ACCESS REPORT

BIOLOGICAL SCIENCES PROJECT

BOTANY STREET, KENSINGTON UNIVERSITY OF NSW

SSD 6674 SUBMISSION

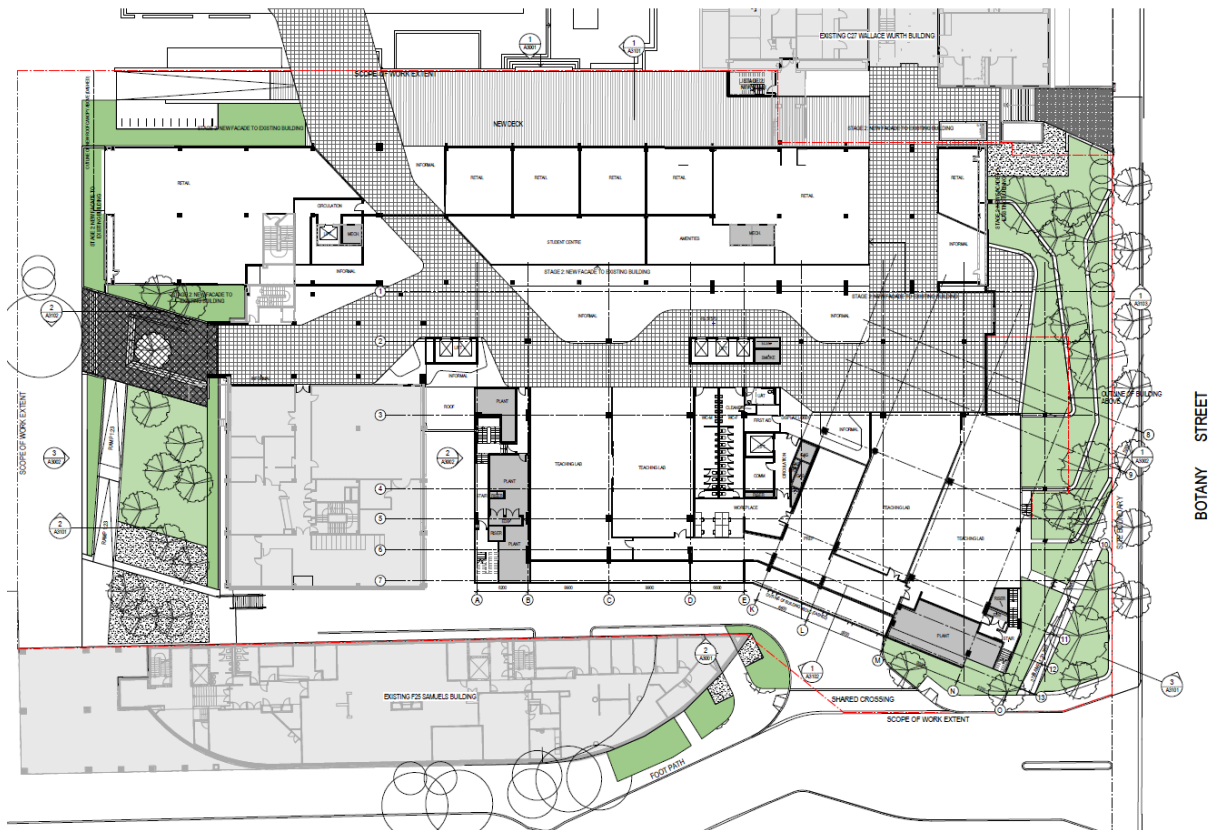
| BCA / DDA Access Code Review | Complies |
|--|---|
| <p>Ground Floor Level</p> <ol style="list-style-type: none"> 1. The development is located in an area that has significant slope across the site that incorporates an accessible building entrance at the lower ground floor and accessible links to the ground floor entrances from the existing building. 2. Ground Floor Entrances – The new building works provide several entrances and entry points to access the building. The Stage I works propose a three principal entries at the ground floor level; <ol style="list-style-type: none"> a) One on-grade level entry from the common walkway adjoining the existing D26 Bio Sciences building and the C27 Wallace Wurth building through the existing D26 Bio Sciences building to the new central atrium foyer area of the new building. b) Second on-grade level entry from a north-western approach through the existing D26 Bio Sciences building to the new building. c) Third entry from the north-south accessway at the western end of the building known as Chancellery Walk that will incorporate a ramped accessway and stairway to access the building entry. 3. Lower Ground Floor Entrance - At the lower ground floor the plans propose an entry doorway with at-grade access from an adjoining vehicular area that enables access to a level corridor and ramped corridor to lifts. | <p>YES</p> <p>YES</p> <p>YES</p> <p>YES</p> |

| BCA / DDA Access Code Review | Complies |
|--|-------------------------------|
| <p>4. The entrance ramps and stairs will be detailed with handrails, tactile ground surface indicators and other features as required by ASI428.1 and ASI428.4.1 to satisfy Parts D3.3 and D3.8 of the BCA and DDA Access Code.</p> | <p>YES at CC stage</p> |
| <p>5. The existing and new entrance doorways indicate double doorways with swing doors that provide circulation spaces that will existing comply with ASI428.1 and satisfy Part D3.2 of the BCA and DDA Access Code. Ideally, these doors will be detailed as auto sliding doors at a future design stage.</p> | <p>YES.</p> |
| <p>6. Doors will be documented at a future stage to confirm 850mm clear opening widths, level threshold, doorway luminance contrast, glazing markings where required and doorway hardware complying with ASI428.1 to satisfy Part D3.2 of the BCA and DDA Access Code.</p> | <p>YES at CC stage</p> |
| <p>7. Overall, the plans illustrate appropriate access to enter the building from all approaches at the ground floor level consistent with ASI428.1 to satisfy Part D3.2 of the BCA and DDA Access Code.</p> | <p>YES</p> |

Lower Ground Floor

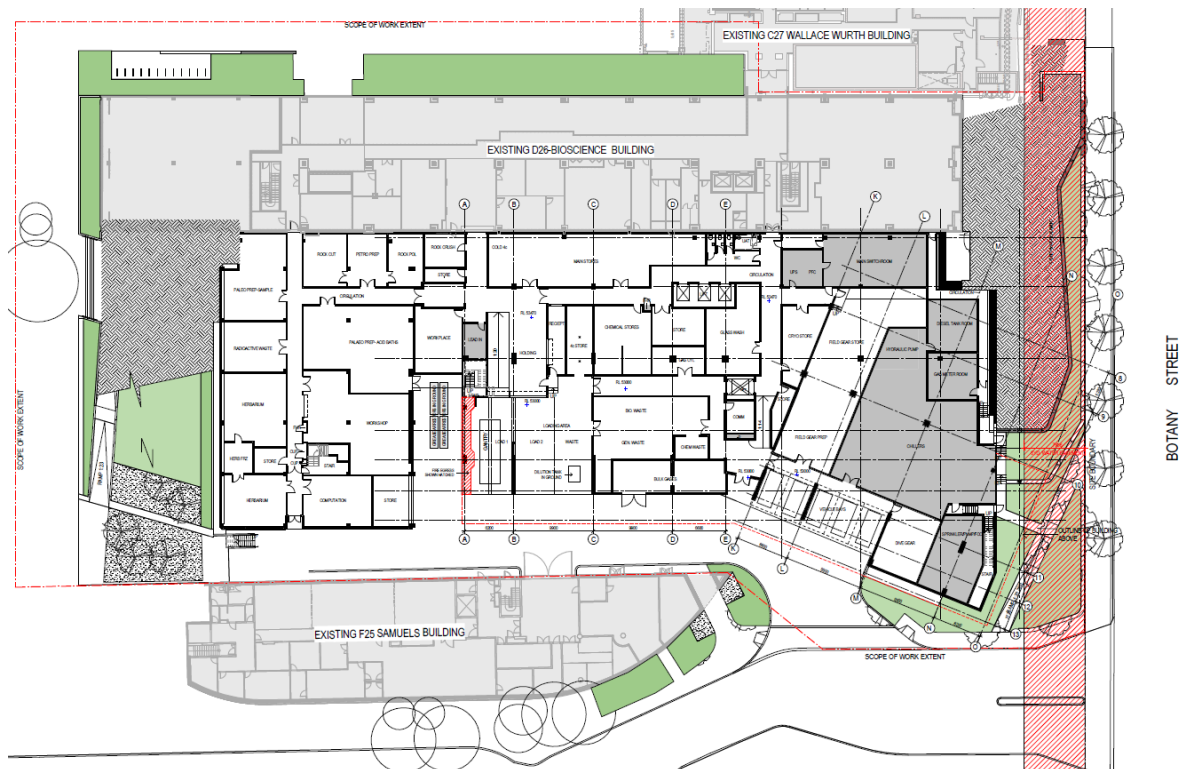
| <p>8. Entrances – At the lower ground floor the plans propose an entry doorway with at-grade access that enables access to a corridor and lifts. The split level design of the lower ground floor incorporates ramps and a lift which has dual ended doorway openings to access the split levels and thereby facilitate equitable access at this level in a manner consistent with ASI428.1 to satisfy Part D3.2 of the BCA and DDA Access Code.</p> | <p>YES</p> |
| <p>9. There are several other external doors at the lower ground floor that can facilitate independent accessible entrances to the Field Gear Prep, Chiller room, Dive gear room and the south-western corridor to achieve equitable access to</p> | <p>YES</p> |

| BCA / DDA Access Code Review | Complies |
|---|---|
| <p>all areas in a manner consistent with ASI428.1 to satisfy Part D3.2 of the BCA and DDA Access Code.</p> <p>10. The external doorways indicate double doorways with swing doors that provide circulation spaces that will comply with ASI428.1 and satisfy Part D3.2 of the BCA and DDA Access Code.</p> <p>11. Doors will be documented at a future stage to confirm 850mm clear opening widths for the active door leaf, level threshold, doorway luminance contrast, glazing markings where required and doorway hardware complying with ASI428.1 to satisfy Part D3.2 of the BCA and DDA Access Code.</p> | <p>YES at CC stage</p> <p>YES at CC stage</p> |

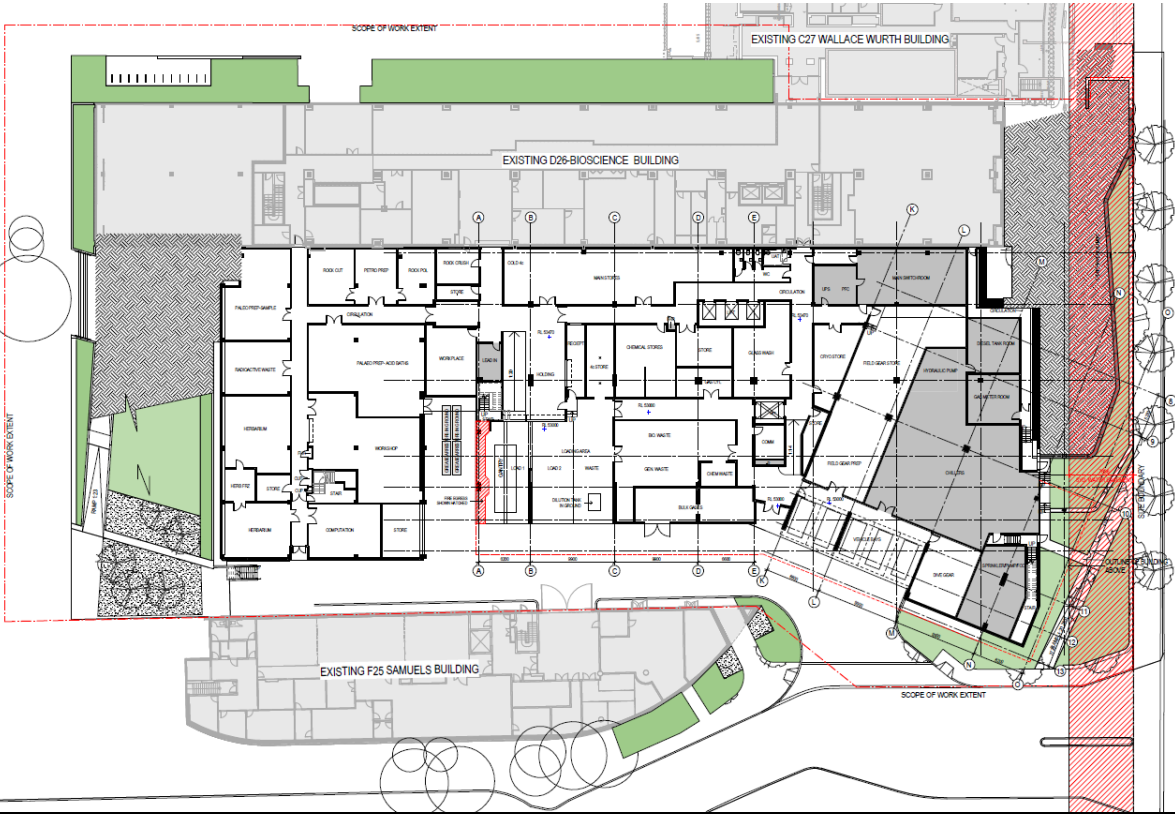
| BCA / DDA Access Code Review | Complies |
|--|-------------------------------------|
| <p>12. Lower Ground Floor Level – The central lift landing provides 3000mm width while the central access corridors propose varying widths of 1600mm-1800mm generally and 2000mm minimum leading to the larger goods/passenger lift.</p> <p>13. The layout of doorways adjoining the central corridors will provide appropriate doorway circulation spaces, 1540mm X 2070mm Turning areas and 1800 X 2000mm Passing bays at the 90 degree turn and 20 maximum intervals in accordance with ASI428.1 to satisfy Part D3.3 of the BCA and DDA Access Code.</p> | <p>YES</p> <p>YES</p> |

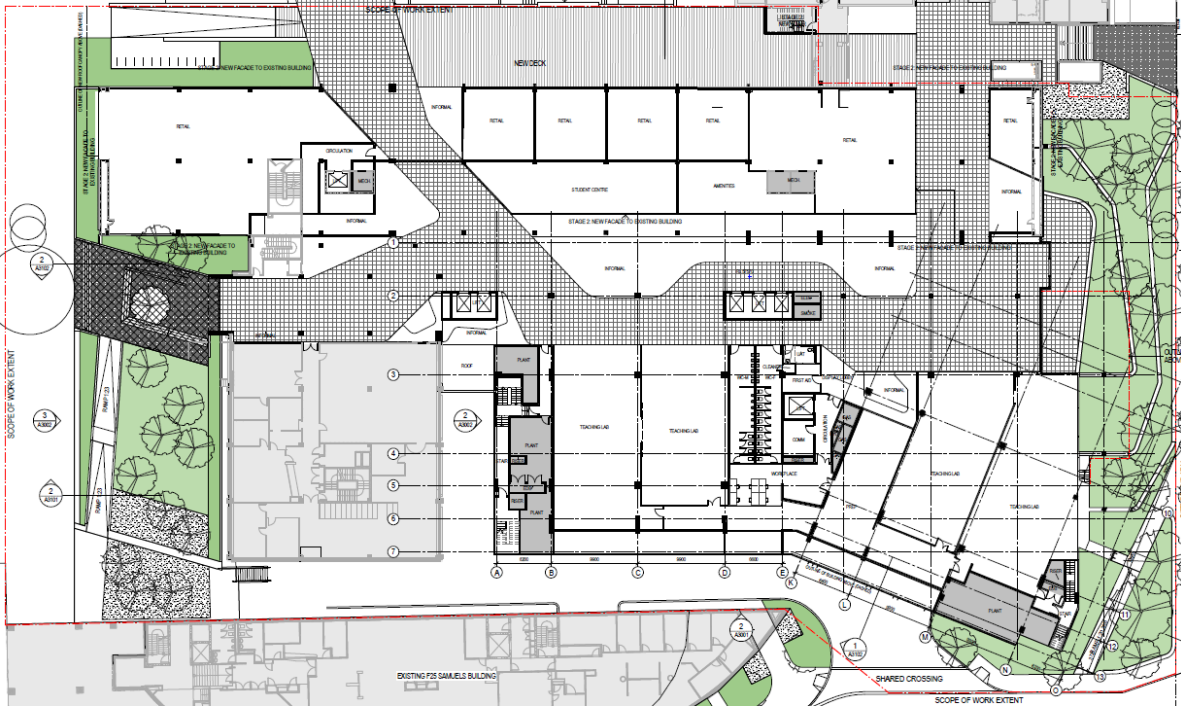
| BCA / DDA Access Code Review | Complies |
|---|--|
| <p>14. The majority of other internal doorways to secondary rooms also provide appropriate doorway circulation spaces complying with ASI428.1 while the use of several plant and equipment rooms will be exempt from disability access requirements due to the uses, which may affect the health of people with disabilities. Such rooms shall be deemed exempt consistent with Part D3.4 of the BCA and DDA Access Code.</p> <p>15. The sanitary facilities adjacent to the central lift landing indicate appropriate access in accordance with ASI428.1 to satisfy Parts D3.3 and F2.4 of the BCA and DDA Access Code, which will be confirmed at a future construction documentation stage.</p> <p>16. With respect to the interface with the adjoining existing building the plans propose two doorways; one double doorway adjoining the lifts and a second door to the western end of the building.</p> | <p>YES</p> <p>YES at CC stage</p> |
| <p>17. While the double doorway inherently provides appropriate circulation spaces the single western door shall require an adjustment to achieve 530mm latchside clearance with a 920mm door.</p> |  <p>YES Can comply</p> |

| BCA / DDA Access Code Review | Complies |
|--|-------------------------------|
| <p>19. The unenclosed stairway within the entry foyer shall require protection from headroom hazards and comply with ASI428.1 and ASI428.4.1 in all regards to satisfy parts D3.3 and D3.8 of the BCA and DDA Access Code.</p> | <p>YES</p> |
| <p>20. The sanitary facilities adjacent to the central lift landing can provide appropriate access in accordance with ASI428.1 to satisfy Parts D3.3 and F2.4 of the BCA and DDA Access Code, which will be confirmed at a future construction documentation stage.</p> | <p>YES</p> |
| <p>21. With respect to the interface with the adjacent existing building the plans propose several open and level corridor links to the northern and western aspects of the existing buildings.</p> | <p>YES</p> |
| <p>22. Doors will be documented at a future stage to confirm 850mm clear opening widths for the active door leaf, level threshold, doorway luminance contrast, glazing markings where required and doorway hardware complying with ASI428.1 to satisfy Part D3.3 of the BCA and DDA Access Code.</p> | <p>YES at CC stage</p> |

Level 1 Floor Plan

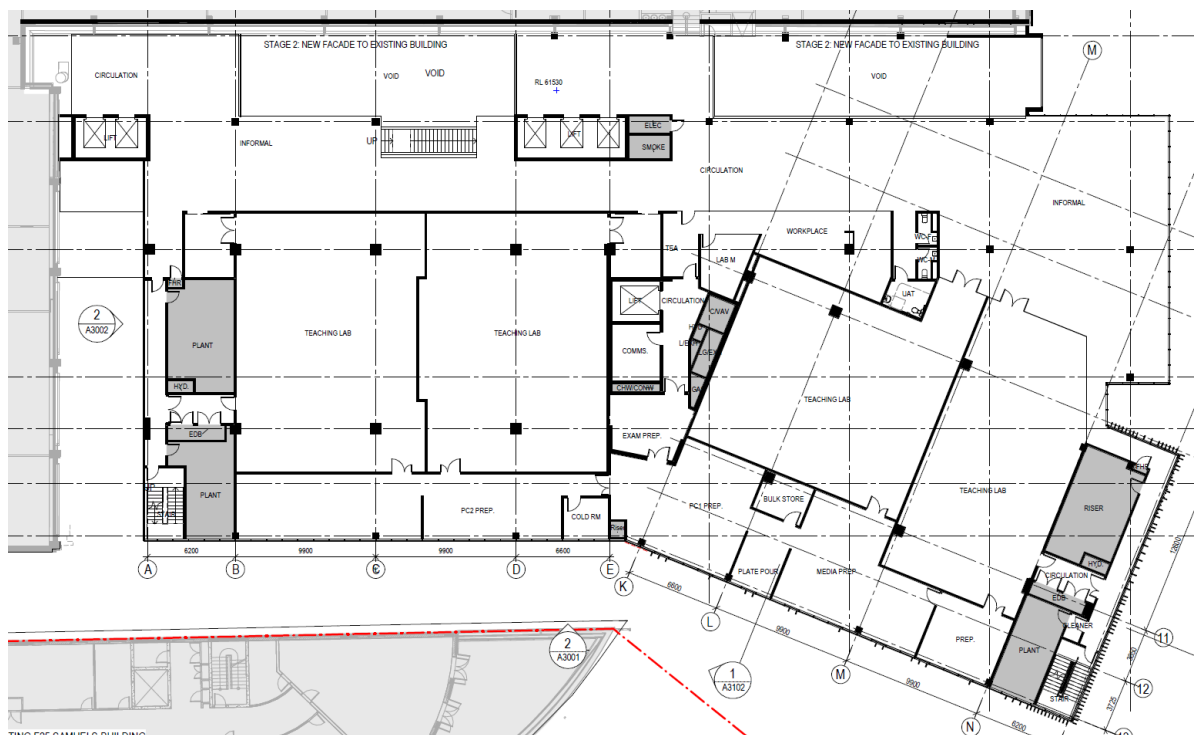
| <p>24. The central lift landing provides ample width while the central access corridors propose varying widths of 3000mm minimum leading to doorways to access several teaching labs, a workplace office, sanitary facilities and corridor link to the larger goods/passenger lift lobby and prep areas to readily comply with ASI428.1, Part D3.3 of the BCA and DDA Access Code in terms of doorway circulation spaces, Turning and Passing areas.</p> | <p>YES</p> |

| BCA / DDA Access Code Review | Complies |
|---|------------------------|
| <p>32. Double doorways to the larger goods/passenger lift lobby and prep areas and single doors to various offices, meeting rooms and sanitary facilities provide appropriate doorway circulation spaces to comply with ASI428.1, Part D3.3 of the BCA and DDA Access Code.</p> | YES |
| <p>34. The western group of sanitary facilities will provide a unisex accessible toilet in accordance with ASI428.1 to satisfy Parts D3.3 and F2.4 of the BCA and DDA Access Code, which will be confirmed at a future construction documentation stage.</p> | YES at CC stage |
| <p>35. Ambulant accessible male and female toilet cubicles are required in accordance with ASI428.1 to comply with Part F2.4 of the BCA and DDA Access Code.</p> | YES at CC stage |

Level 6

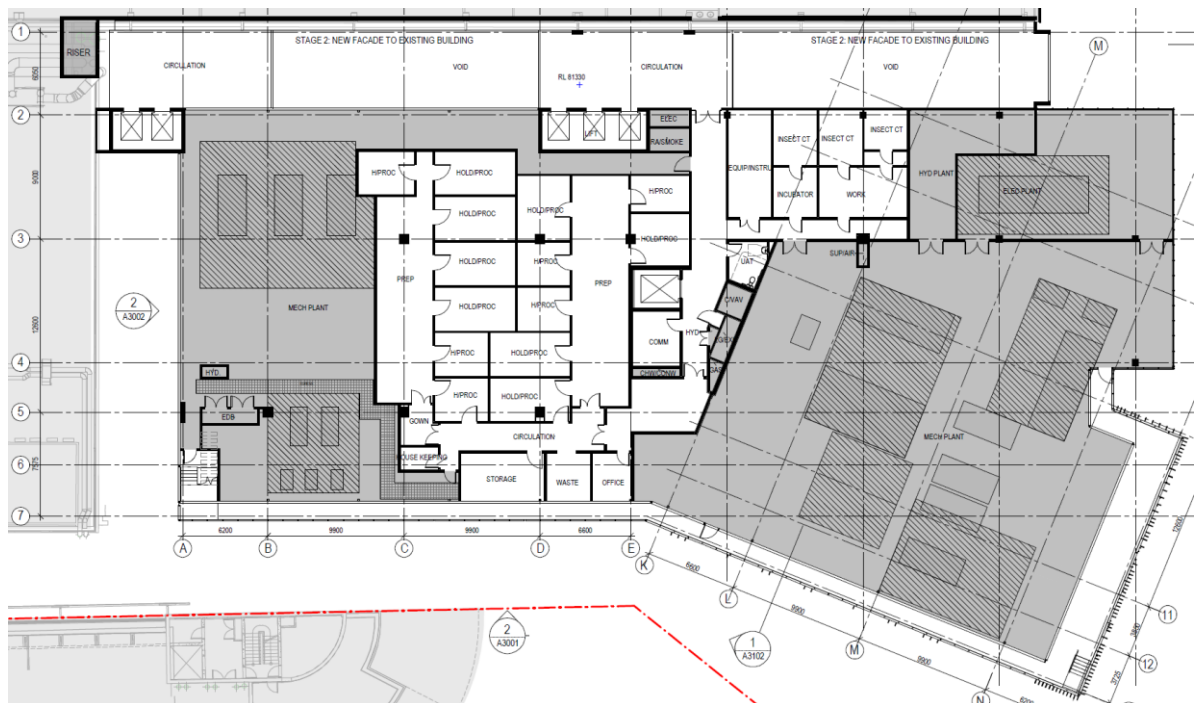
| <p>36. The central lift landing provides ample width with a double doorway to a 2400mm minimum width corridor to the goods/passenger lift to comply with ASI428.1, Part D3.3 of the BCA and DDA Access Code in terms of doorway circulation spaces, Turning and Passing areas.</p> | YES |
| <p>37. The 1400mm width corridor to several offices shall require a 1540 X 2070mm Turning Area at the end of the corridor to comply with D3.3 of the BCA and DDA Access Code. If outward swing doors are required for the Incubator and adjacent rooms then corridor is required to be 1670mm minimum width to comply with ASI428.1</p> | Can Comply |
| <p>38. Access corridors to and within various equipment rooms, Holding/Processing Rooms and offices comply with ASI428.1, Part D3.3 of the BCA and DDA Access Code in terms of doorway circulation spaces, Turning and Passing areas.</p> | YES |

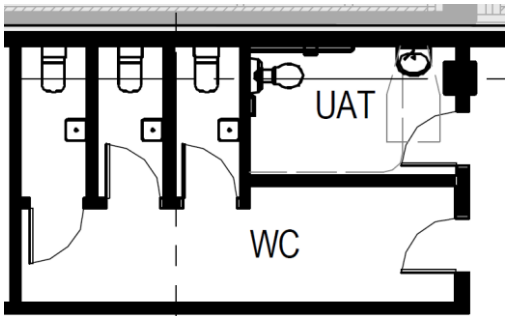
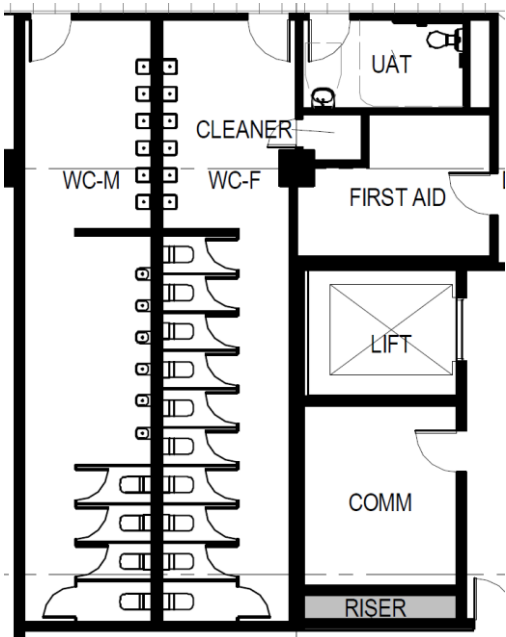
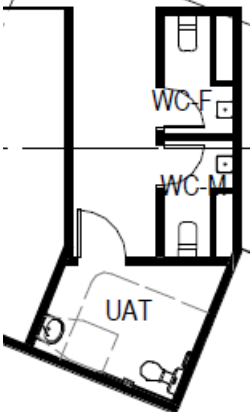
| BCA / DDA Access Code Review | Complies |
|--|---|
| <p>47. Lower Ground Floor level provides a central group of sanitary facilities that includes a unisex wheelchair accessible toilet unisex while the male and female facilities will require detailing of ambulant accessible toilets.</p> |  <p>YES</p> |
| <p>48. Ground Floor level provides a central group of sanitary facilities that includes a unisex wheelchair accessible toilet unisex while the male and female facilities will require detailing of ambulant accessible toilets.</p> |  <p>YES</p> |
| <p>49. Level I provides an area designated for sanitary facilities which will require detailing of a unisex wheelchair accessible toilet, male and female ambulant accessible cubicles.</p> |  <p>YES</p> |

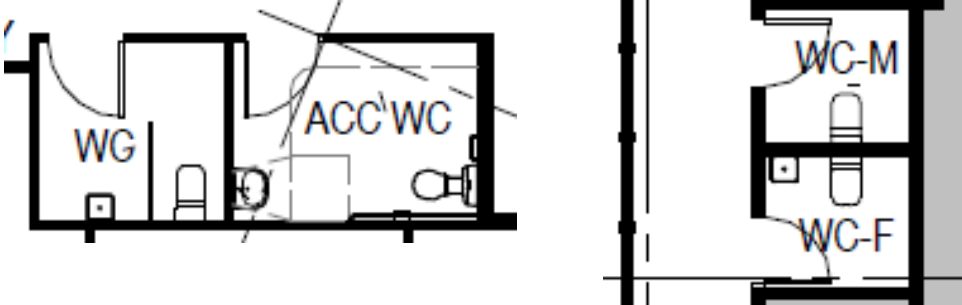
| BCA / DDA Access Code Review | Complies |
|--|------------------------|
| <p>50. Levels 2 to 5 provide three (3) banks of toilets with the western and central group providing a unisex wheelchair accessible toilet and male and female toilets that will require detailing of an ambulant male and female accessible cubicle.</p>  | <p>Can Comply</p> |
| <p>51. Level 6 provides one (1) unisex wheelchair accessible toilet.</p>  | <p>YES</p> |
